MeshSat field kit V2, Option A(i) lid pack: sheet A1-1 arrangement B in plan: the lid module, the QMX set and every face part under the lid

MESH SAT-1357, stream a1mech, 29 Sep 2026. Case frame: X east, Y toward the hinge (back) wall, Z up from the base floor, lid closed. mm. Prototype design, AI review: nothing built, bought or fitted; analytical success is not physical verification.

MeshSat field kit V2, Option A(i) lid pack: sheet A1-3 the arrangements that fit, and the owner decision

MeshSat field kit V2, Option A(i) lid pack: sheet A1-4 the hinge harness: route, travel, ties, disconnect; the QMX DC lead re-routed

MeshSat field kit V2, Option A(i) lid pack: sheet A1-6 the base pockets: section 8's 4S6P at the same worst figures

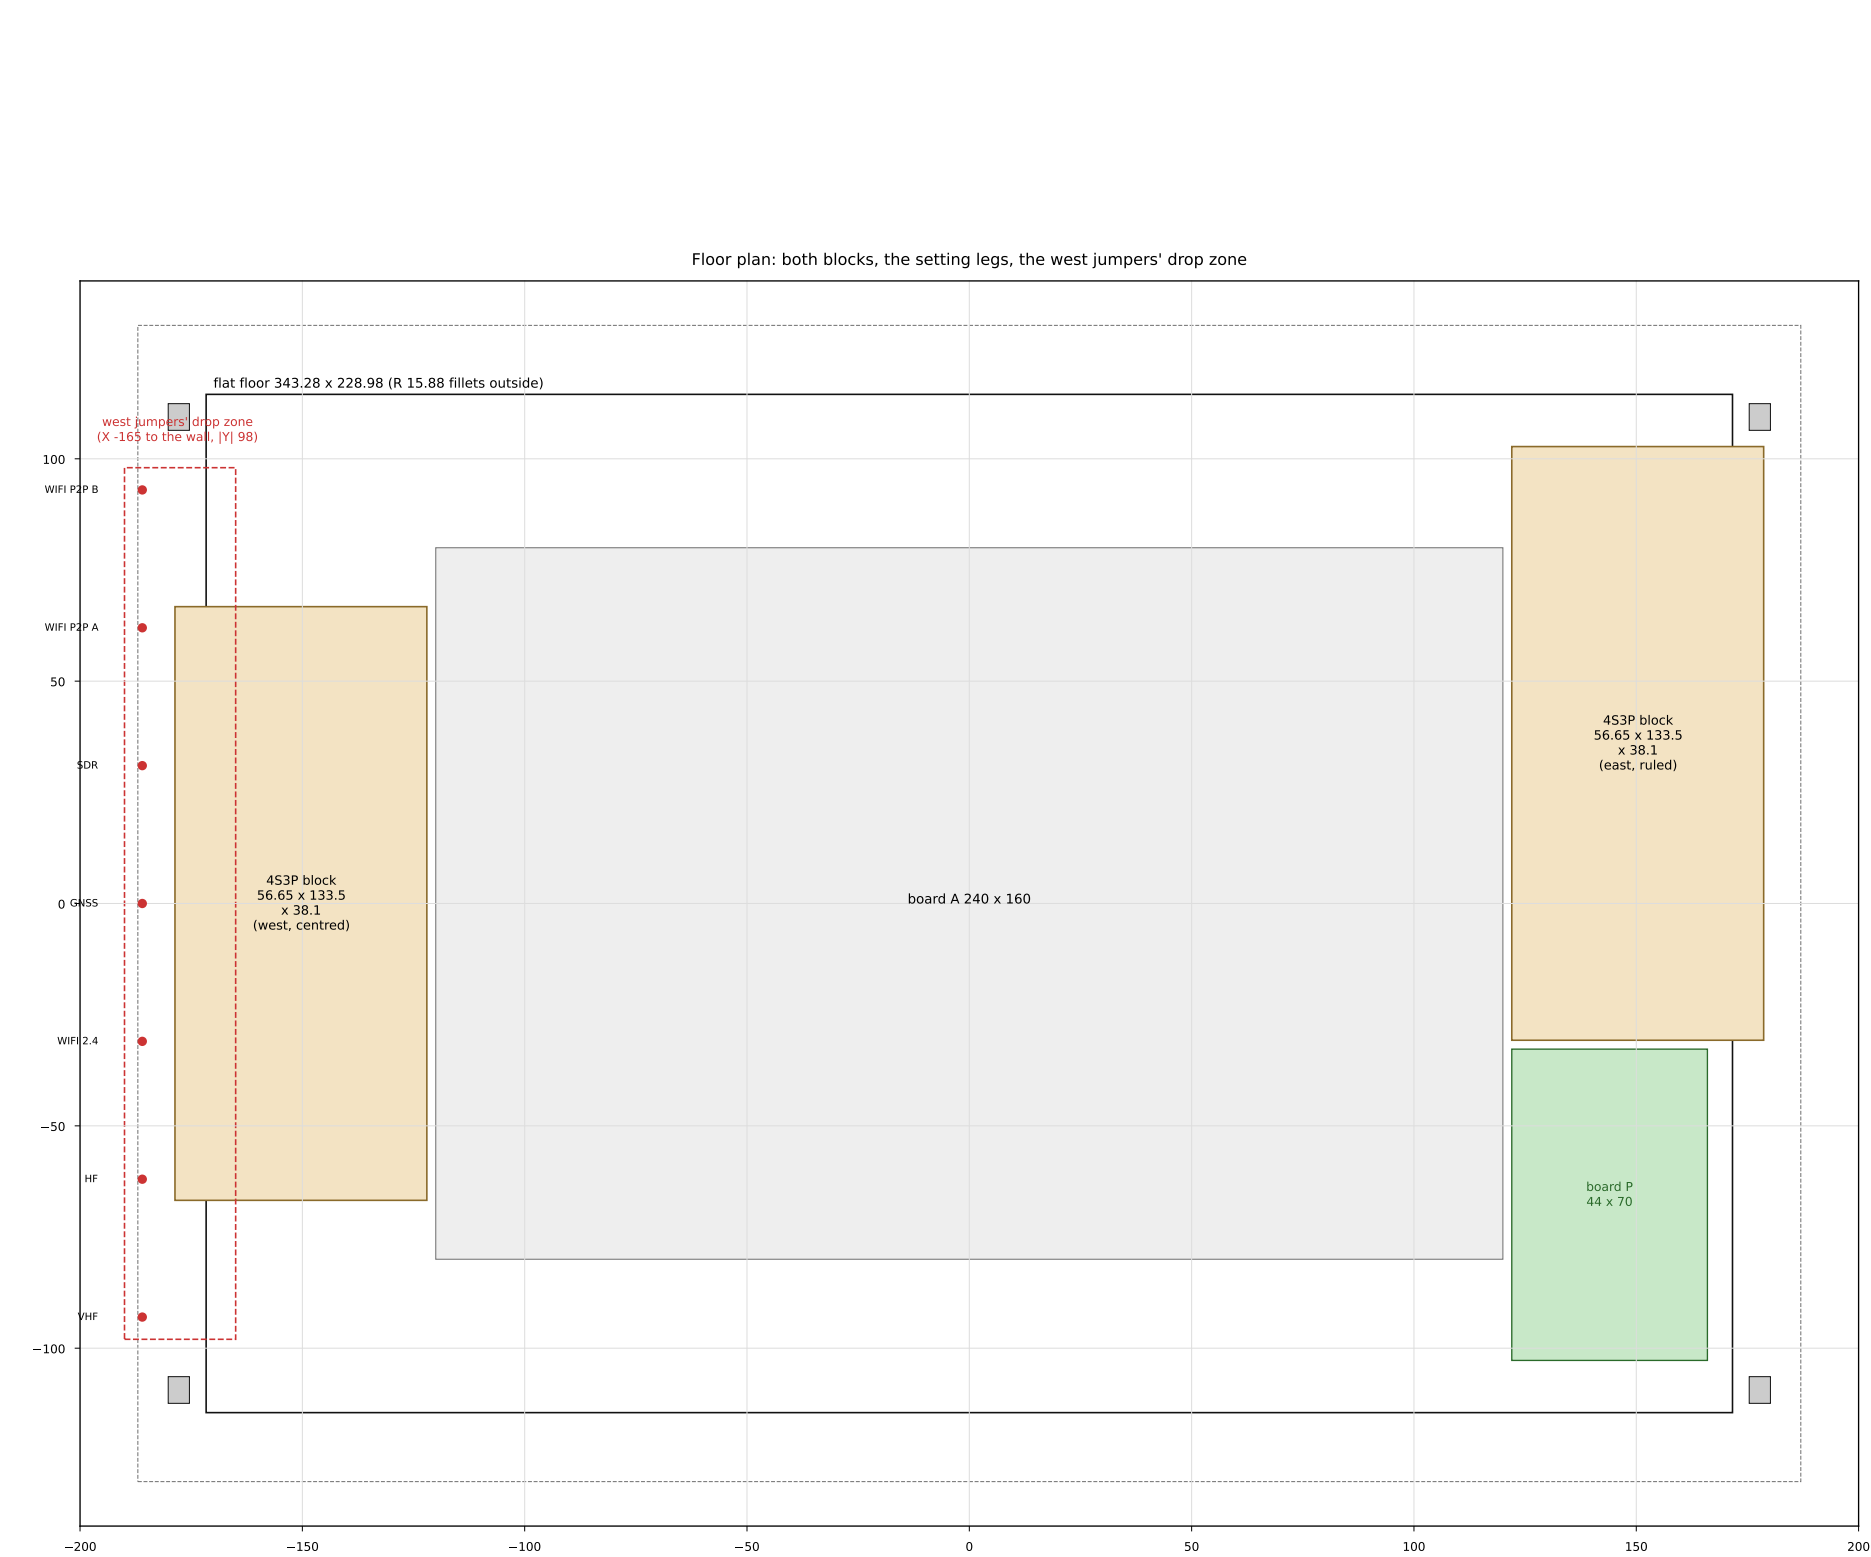
ROW	worst	x2	verdict
M4a	1.85	0.85	OPEN: placed by hand; T4
M4aw	1.85	0.85	OPEN: placed by hand; T4 (mirror: Peli's cavity and
M4b	7.38	6.38	MET
M4bw	7.38	6.38	MET (mirror: Peli's cavity and the RF entry plates a
M4c	3.18	1.80	MET
M4cw	3.18	1.80	MET (mirror: Peli's cavity and the RF entry plates a
M5	1.77	0.27	OPEN: placed by hand, the legs' locator; T4
M5w	37.77	36.89	MET (the block's Y place is not ruled; centred here)
M6	3.66	2.90	MET
M6w	3.99	n/a	OPEN: the x2 reading is not computed by A06's tool;

WEST RF JUMPERS: 5 of 7 west cables (Y -62, -31, 0, 31, 62) fall onto the west block; the slot over it is 7.19 at the worst less C33's zone (3.99); the only drop east of it is its 2.0 gap to board A, under one RG-316 (2.49): FAILS AS ASSUMED, held OPEN (section 8b, the M17 class): the west RF entry is re-planned before the west block is taken. Hold-down S-27 open for both blocks.
